## Appendix I

### Dumaresq – Lismore Transmission Line Project - Circuit Breaker Arrangement

**Figure 2**  
**TransGrid Proposed Connection Arrangement at Dumaresq**

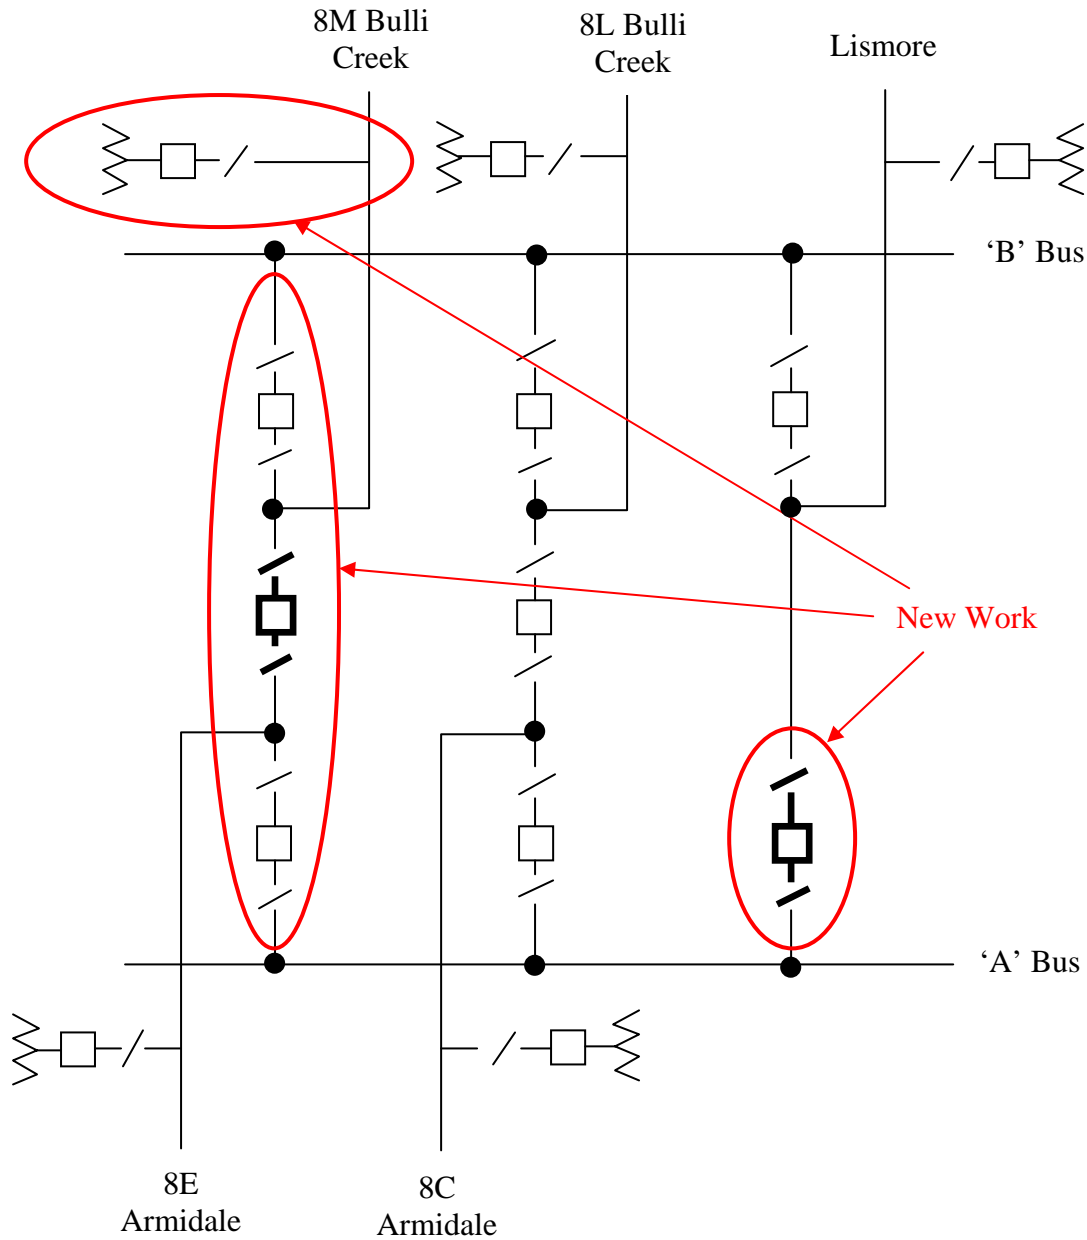
*The substation works at Dumaresq require five new circuit breakers to be installed in a breaker and half arrangement. In PBs view two of these circuit breakers only provide limited benefits under normal situations (but they do marginally improve operational flexibility and increase the extent of redundancy).*

While not identified in the PB report, correspondence between PB and TransGrid has identified the circuit breakers to be the centre circuit breaker in the breaker and half scheme, and the second circuit breaker for the Lismore line shown in bold in Figure 2.

*The AER agrees with PB's findings that TransGrid has not reasonably demonstrated that all of the circuit breakers identified by TransGrid are required by a prudent and efficient TNSP in TransGrid's circumstances*

The net financial result of this decision to remove two circuit breakers is a reduction of \$2.6M

TransGrid concurs with PB's opinion that the connection of the Lismore line through a double breaker arrangement that it offers greater operational flexibility and reliability. However, TransGrid is prepared to accept the AER's advice that the higher customer service levels delivered by this arrangement do not justify the additional expenditure.

**Figure 3**  
**AER Proposed Connection Arrangement at Dumaresq**

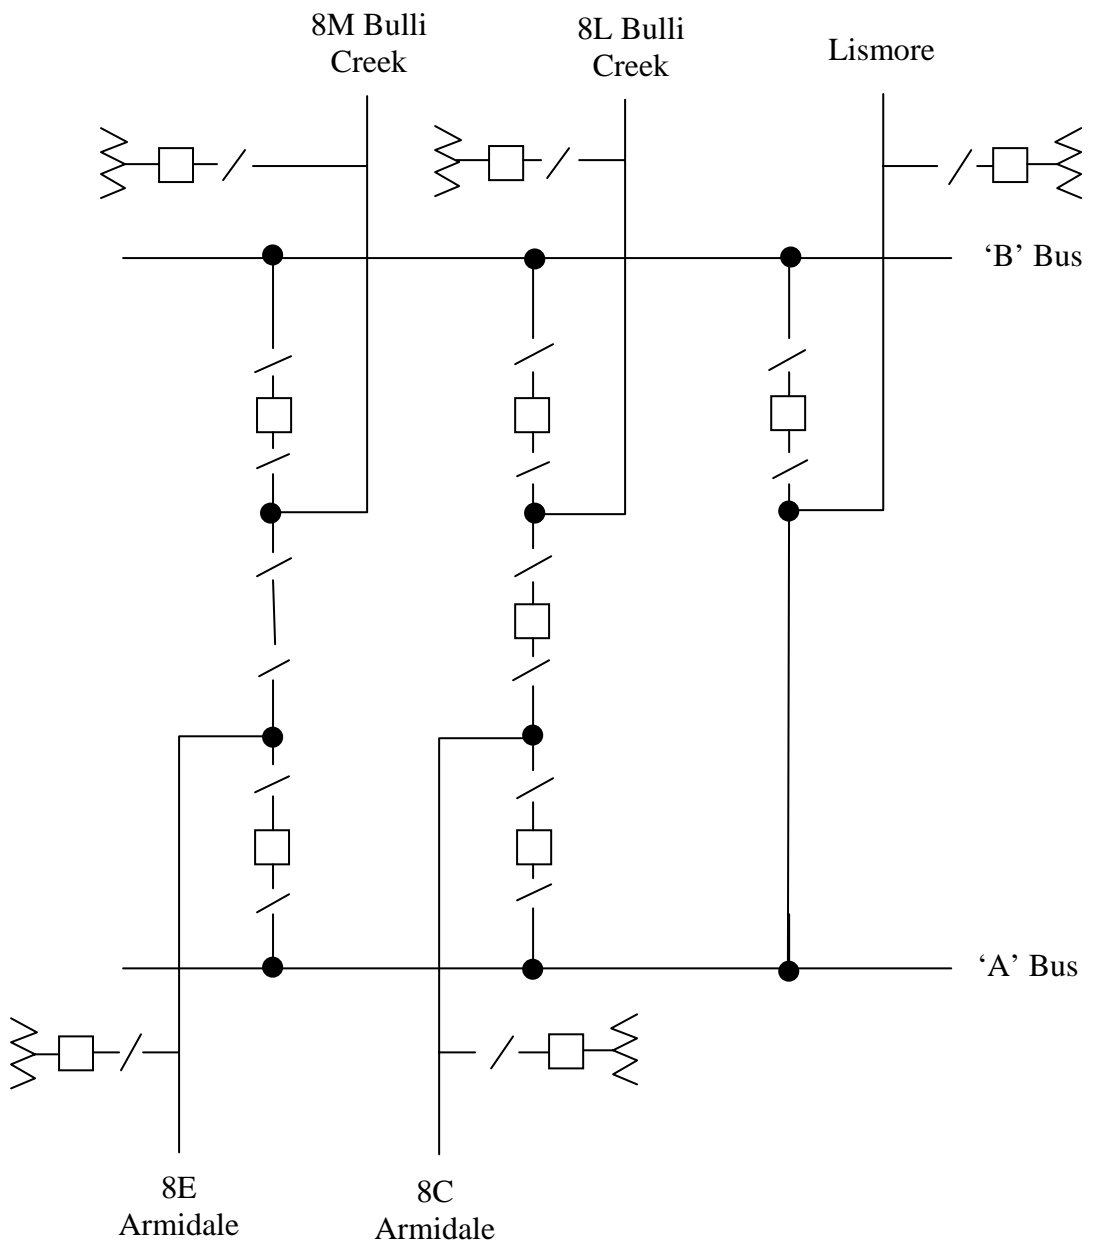
The connection arrangement proposed by the AER for Dumaresq is shown in Figure 3.

The AER provided no analysis to support the proposed busbar arrangement is reasonable.

TransGrid does not concur with the AER's advice that the removal of the centre circuit breaker in a breaker and half arrangement is either efficient or prudent. TransGrid believes that the arrangement proposed by the AER is:

- inconsistent with good electricity industry practice for the major flow paths;
- imposes a substantive reduction in reliability and operational flexibility from that which presently is in place and for which this switching station has been designed;
- will require the introduction of additional constraints on the flowpath to undertake maintenance that could otherwise be avoided. These constraints may potentially have a significant financial impact on market participants;
- will require the separation of Queensland from the remainder of the NEM for the maintenance of equipment in the single centre switchbay. TransGrid believes the separation of Queensland from the remainder of the NEM may have a significant financial impact on market participants.

TransGrid has considered the issues raised by the AER and believes the arrangements proposed by the AER to remove the centre circuit breaker is highly inappropriate and the AER has not acted reasonably. TransGrid therefore seeks to have the value of \$1.3M for this circuit breaker restored. TransGrid's revised proposed arrangement is shown in Figure 4.
